UNITED STATES PATENT AND TRADEMARK OFFICE

APPLICATION NO.	FILING DATE	FIRST NAMED INVENTOR	ATTORNEY DOCKET NO.	CONFIRMATION NO.
10/520,463	10/07/2005	Agostino Di Trapani	Q85687	5533

Office Action Summary

DETAILED ACTION

Figure 3: Roberts (US 822,078)

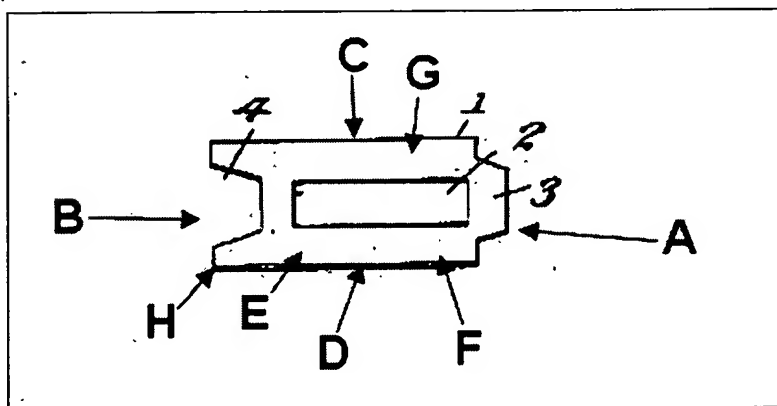
construction element (F), where the construction element (F) comprises at least one protuberance or tenon (3), which extends over the lower face (A) of the construction element. The mortise (4) is arranged in such a way to correspond with a tenon (10) of the similar construction element (F) so as to allow for the assembly of two construction elements (F). The mortise (4) is associated with a load-bearing wall (G) of the construction element (F) and is arranged a distance from the outer lateral edge (H) of the construction element (F). All the limitations regarding the binder has little patentable weight, as the binder relates to an intended use with a construction element as recited, "The distance of mortise being arranged from the outer lateral edge of the construction element, which is sufficient to prevent the overflow of binder beyond the edge of the element during assembly, characterized in that the mortise and the tenon are dimensioned in such a way as to allow, during the assembly of two elements, for a partial embedding such as will allow for a strip of binder to be formed between the upper face and the lower face of the elements, the sole contact between the two superimposed elements therefore being by way of this strip so as to allow for an adjustment of the alignment, of the height, and of the plumb alignment of the elements which are to be assembled."

With regards to claim 22, Roberts further discloses the depth of the mortise (4) and the height of the tenon (3) being approximately equal. The tolerance will inherently be proportional to the depth of the mortise (4) and height of the tenon (3), which is to be accommodated with the construction element (F).

With regards to claim 23, The ratio of the weight of the construction element (F) to the surface area of the small base of the trapezoidal of the tenon (6) will inherently be inversely proportional to the fluidity of the binder placed between two construction elements (F), so as to allow for proper alignment of the assembly.

With regards to claim 29, Roberts further discloses a mortise (4) that is designed to accommodate equally a simple or straddle fitting (figure 1).

With regards to claim 35, Roberts discloses a wall constructed with a plurality of construction elements (F), where the wall is constructed with "thin joints" between the construction elements (figure 1).

With regards to claim 36, Roberts further discloses a wall that comprises the assembly of the construction elements (F), where each construction assembly comprises at least two preassembled construction elements (F).
